Byron Environmental Audit – Request for Additional Information Response

Question #: HH-2

Statement of Question:

A schematic diagram of the meteorological monitoring instruments from the tower to the control room is attached to this response [Drwg. 6E-0-4031EM01, Rev. E].

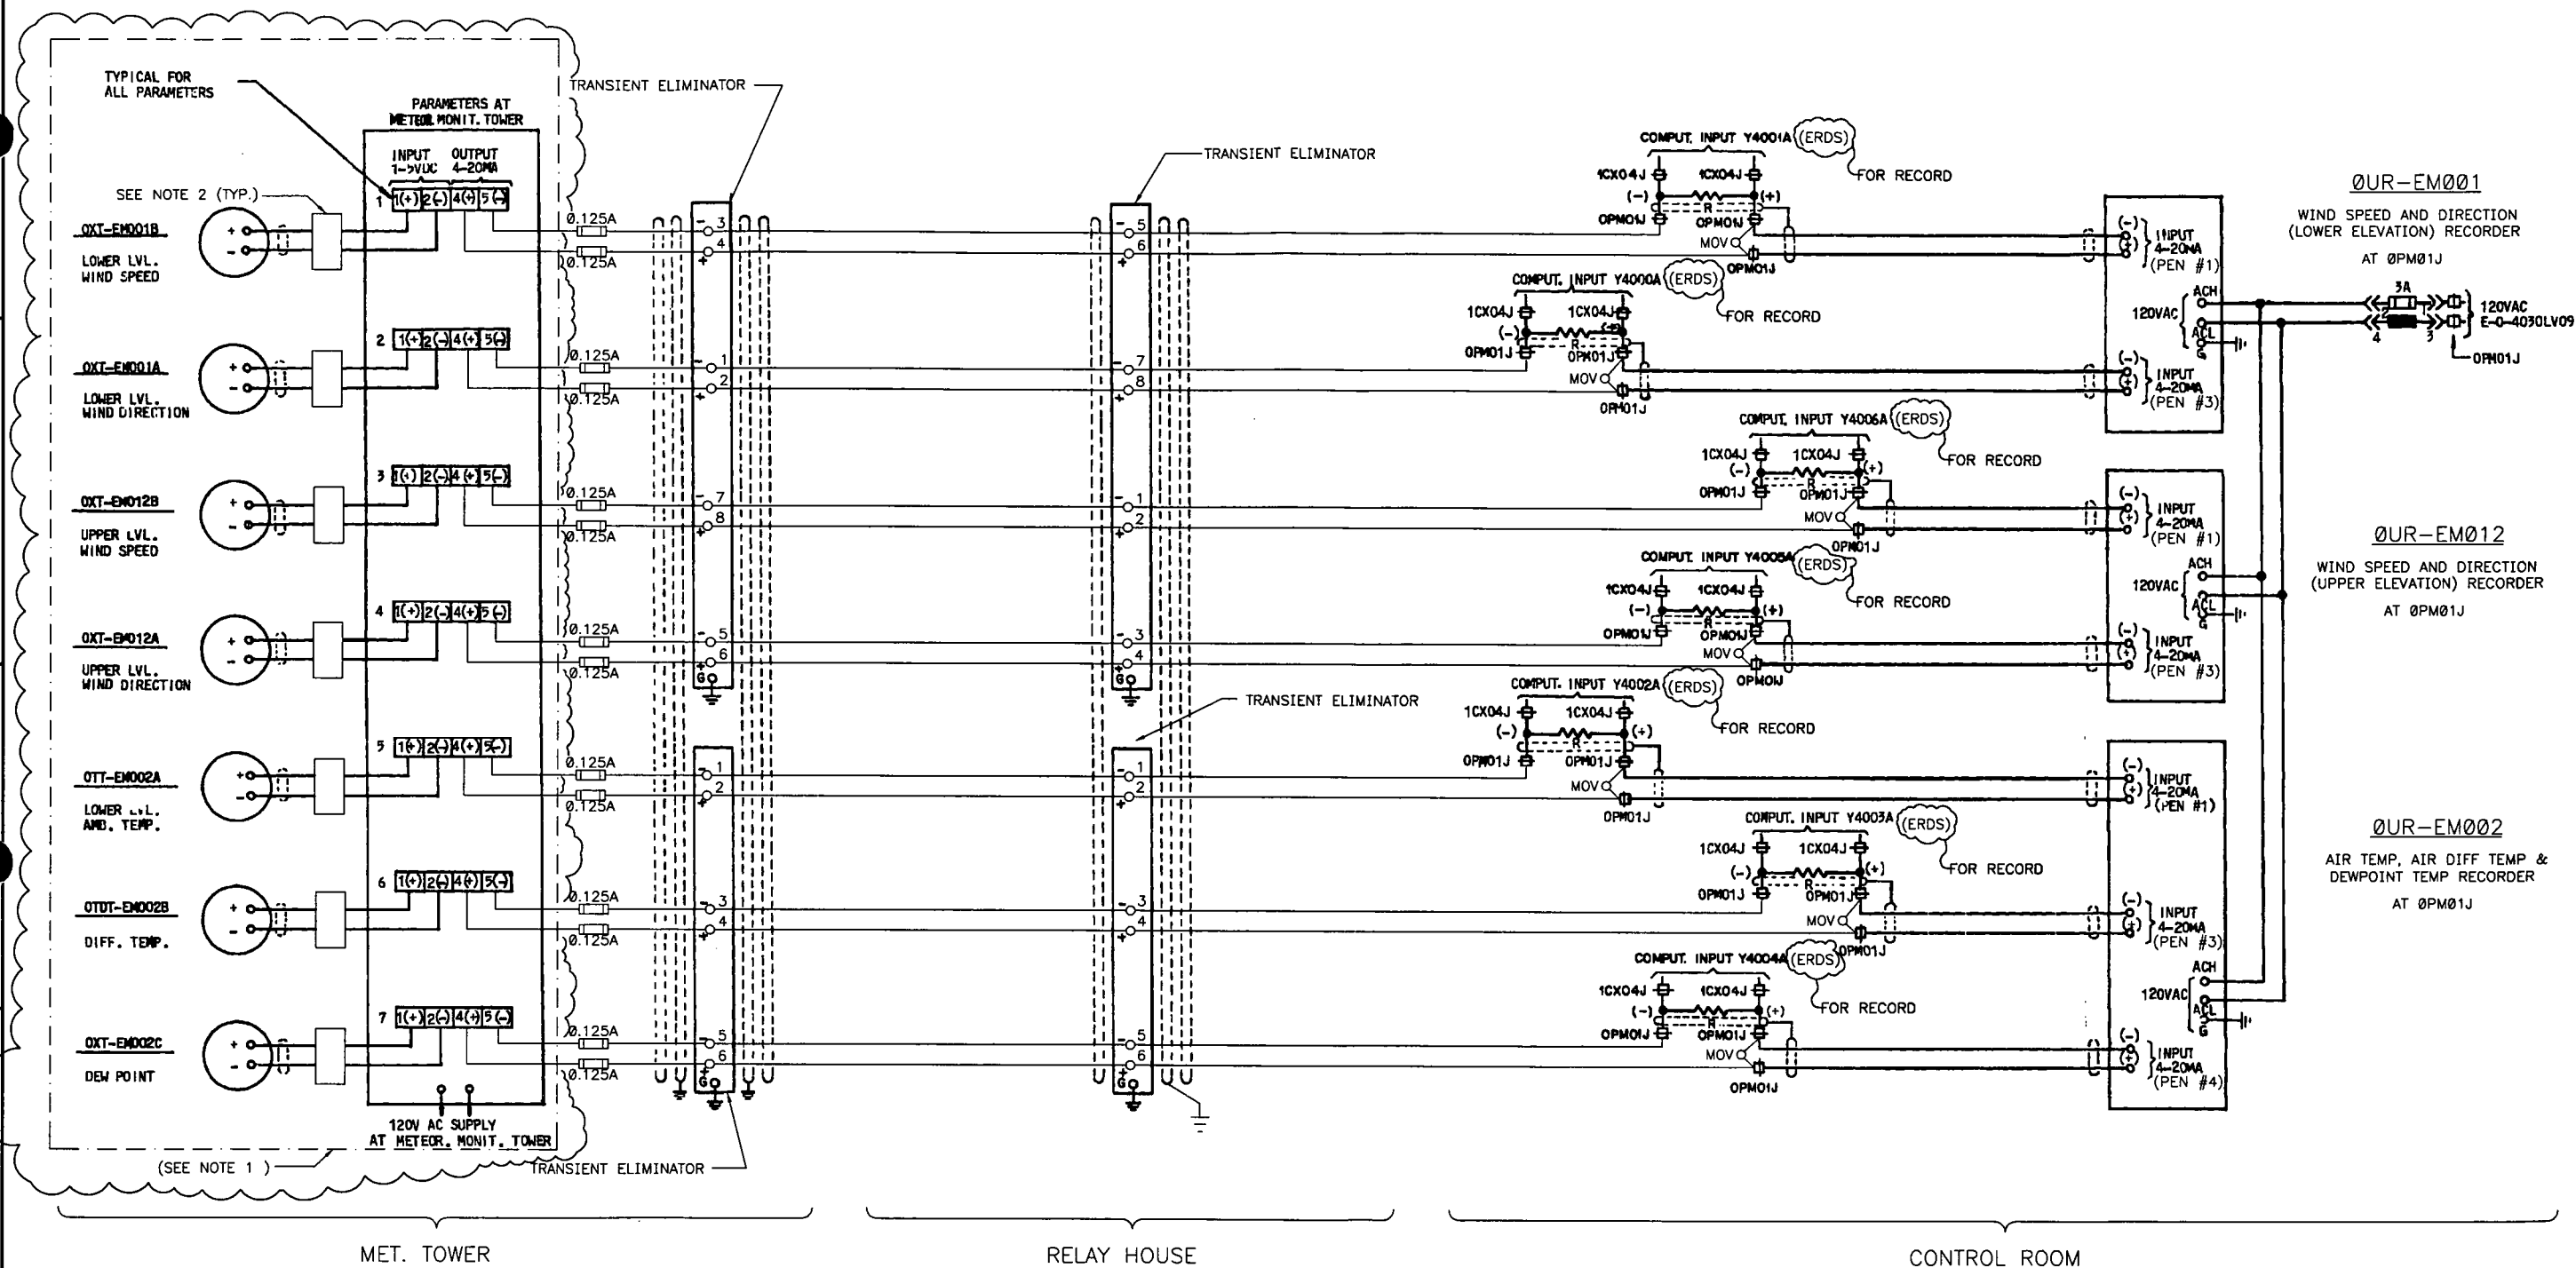
Provide the following meteorological information from the data recorded at Byron's meteorological facility. The meteorological data should include the most recent 5 years for which data is available. Provide the following information:

- Mean monthly and annual temperatures.
- Mean monthly precipitation and annual precipitation.
- Seasonal and annual summary wind statistics in the form of wind direction and speed frequency distribution tables and wind roses. Discuss predominant wind direction and speed by season and annual average, local terrain features affecting wind direction and speed, and provide a value for annual average wind speed.
